7. Lease Name or Unit Agreement Name  
 Hillbilly Cave 8 St.

**SUNDRY NOTICES AND REPORTS ON WELLS**  
 (DO NOT USE THIS FORM FOR PROPOSALS TO DRILL OR TO DEEPEN OR PLUG BACK TO A DIFFERENT RESERVOIR. USE "APPLICATION FOR PERMIT" (FORM C-101) FOR SUCH PROPOSALS.)

2. Name of Operator  
 Marathon Oil Permian, LLC

### VERTICAL WELLBORE DIAGRAM

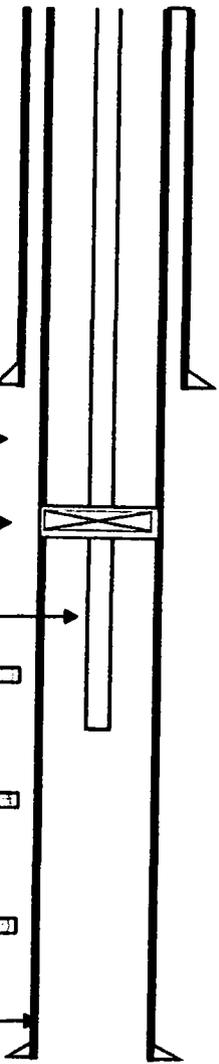
- 5 1/2 CIBP @ 3800' w/25sx.
- 20sx 2050'-1950'.
- 20sx 710'-610'.
- 35sx 354' to surf. Verify.
- Install DHM.

Note: 10-1-2010 CBL TOC 5 1/2 @ 85'.

P&A mud between all plugs.  
 Closed loop.  
 All fluids to licensed facility.

\* See Attached COA's

Must be Plugged by 9-21-19
